Access Compliance Report

Public Rights-of-Way

(Curb Ramps)

Intersection ID: 8116	Main Street: GOSSETT_AV	Cross Street: S_HOSKINS_RD	Location:	N
ADA ID: 5CE8AFAFB8D7	Ramp Type: Perp	Initial Pass/Fail: Fail	Overall Compliance: No	Severity Score: 10
Codes/Mitigation Info/Possible Solution		Field Measurements/Component Compliance

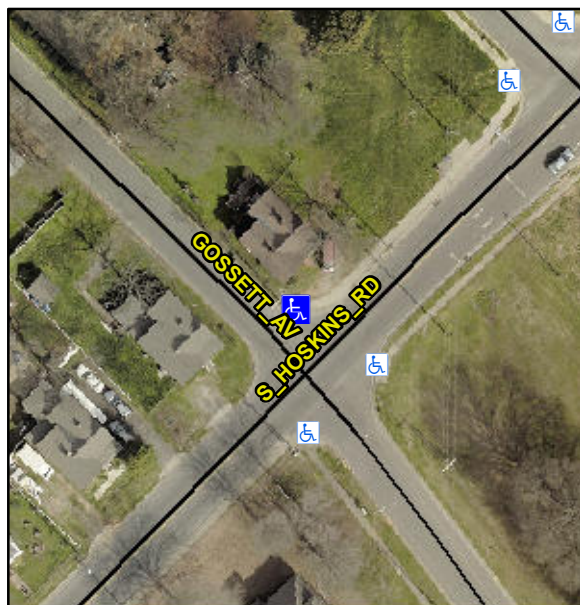
Not Found, R304.5.1, R304.5.3

Compliance	Description	Data	Compliance	Description	Data
N/A	Ramp Length (in)	69.0	Yes	Ramp Slope (%)	5.9
No	Ramp Width (in)	47.5	No	Ramp XSlope (%)	2.1
N/A	Flare Type LT	N/A	N/A	Flare Type RT	N/A
N/A	Flare Slope LT (%)	N/A	N/A	Flare Slope RT (%)	N/A
N/A	Flare Traversable LT?	N/A	N/A	Flare Traversable RT?	N/A
N/A	Landing Length (in)	N/A	N/A	DWS Provided?	N/A
N/A	Landing Width (in)	N/A	N/A	DWS Contrast?	N/A
N/A	Landing Slope (%)	N/A	N/A	DWS Length (in)	N/A
N/A	Landing X Slope (%)	N/A	N/A	DWS Full Width?	N/A
N/A	Landing Curb? (Y/N)	N/A	N/A	DWS Offset (in)	N/A
N/A	Shared Landing?	N/A			
N/A	Gutter Ponding?	N/A	N/A	Gutter Slope (%)	N/A
N/A	Gutter Lip Ht (in)	N/A	N/A	Gutter X Slope (%)	N/A
N/A	Painted X Walk1?	No	N/A	Painted X Walk2?	N/A
	X Walk 1 Direction	To SW		X Walk 2 Direction	N/A
N/A	X Walk 1 Width (in)	N/A	N/A	X Walk 2 Width (in)	N/A
	X Walk 1 Slope (%)	0.5		X Walk 2 Slope (%)	N/A
	X Walk 1 X Slope (%)	1.0		X Walk 2 X Slope (%)	N/A

Remove & Replace Entire Ramp.
